UNITED STATES
DEPARTMENT OF THE INTERIOR
BUREAU OF LAND MANAGEMENT
OCD-ARTESIAFORM APPROVED
OMB No. 1004-0137
Expires: March 31, 2007**SUNDRY NOTICES AND REPORTS ON WELLS**

Dunn Federal #1

30-015 - 01819

OXY USA Inc. - Proposed
Dunn Federal #1
API No. 30-015-01819

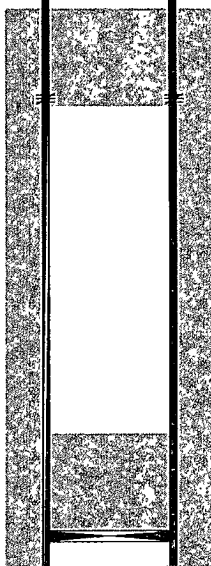
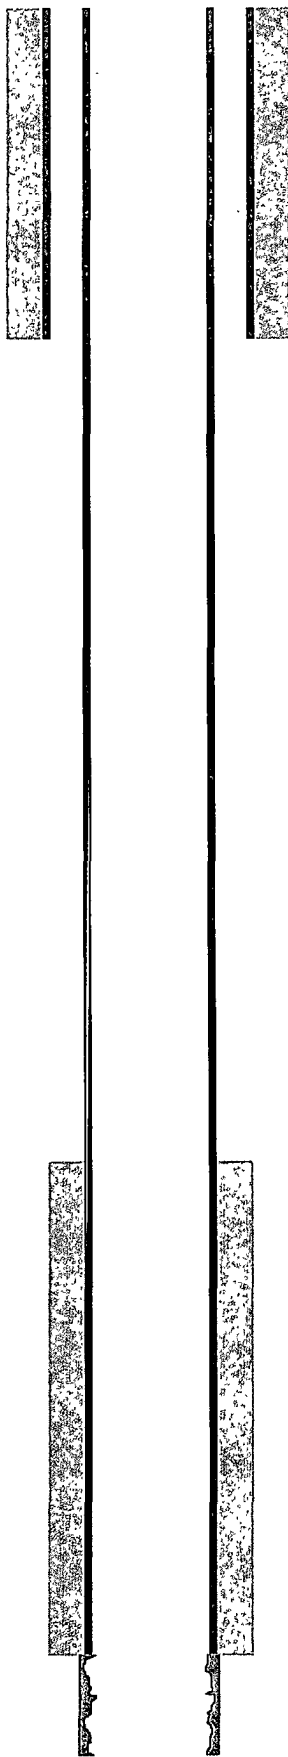
2. Perf @ 1815' sqz 45sx cmt to 1695' WOC-Tag Perf @ 1900' cmt to 1780'

3. Perf @ 545' sqz 175sx cmt to Surface Perf @ 728' cmt to circ.

at cutoff cap
all annulus to surf.

③ Perforate @ 728' squeeze
cmt to surf.

② Perforate @ 1900' Squeeze w/
adequate cmt to fill 120' in/out
w/o tag

① Set CIB @ 2439, cap w/ 30 SX cmt
